PLANNED UNIT DEVELOPMENT & PLANNING APPROVAL STAFF REPORT

NAME U M S- Wright School

LOCATION 65 North Mobile Street

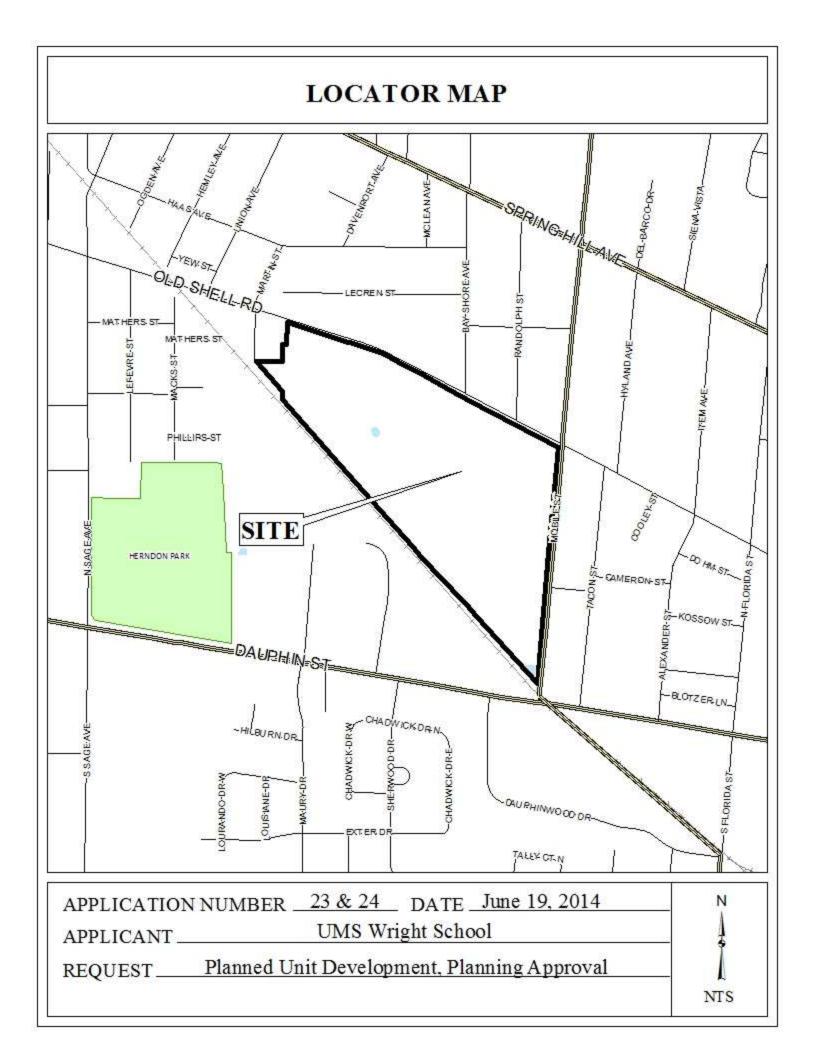
The total square footage of the proposed athletic building is not illustrated on the site; however both the athletic building and storage buildings will be appropriately setback from the property line adjacent to the railroad right-of-way to the South. The location of the facility will not increase parking requirements for the school. It should be noted, however, that the site plan does not appear to accurately depict the relocated buildings approved as part of the 2013 applications.

It should be pointed out that the site plan for the Planning Approval application is labeled "Revised PUD for UMS Wright Preparatory School". This should be revised to say "Planning Approval Site Plan for UMS Wright Preparatory School". Two revised copies correcting the labeling of the PA site plan will be required.

- 2) revision of the PA and PUD site plans to accurately depict the location of all structures, inc. storage buildings;
- 3) compliance with revised Engineering comments: "1. Any work performed in the existing ROW (right-of-way or public drainage easement) such as driveways, sidewalks, utility connections, grading, drainage, irrigation, or landscaping will require a ROW permit from the City of Mobile Engineering Department (208-6070) and must comply with the City of Mobile Right-of-Way Construction and Administration Ordinance (Mobile City Code, Chapter 57, Article VIII). 2. A Land Disturbance Permit application shall be submitted for any proposed land disturbing activity with the property. A complete set of construction plans including, but not limited to, drainage, utilities, grading, storm water detention systems, paving, and all above ground structures, will need to be included with the Land Disturbance permit. This Permit must be submitted, approved, and issued prior to beginning any of the construction work. 3. Any and all proposed land disturbing activity within the property will need to be submitted for review and be in conformance with the Storm Water Management and Flood Control Ordinance (Mobile City Code, Chapter 17, Ordinance #65-007 & #65-045); the City of Mobile, Alabama Flood Plain Management Plan (1984); and, the Rules For Erosion and Sedimentation Control and Storm Water Runoff Control. 4. The detention facility shall be maintained as it was constructed and approved. The Land Disturbance Permit application for the construction shall include a Maintenance and Inspection Plan signed and notarized by 5. The proposed development must comply with all Engineering the Owner(s). Department Policy Letters.";

- 8) full compliance with all municipal codes and ordinance; and
- 9) submission of a revised PUD site plan prior to any request for permits.
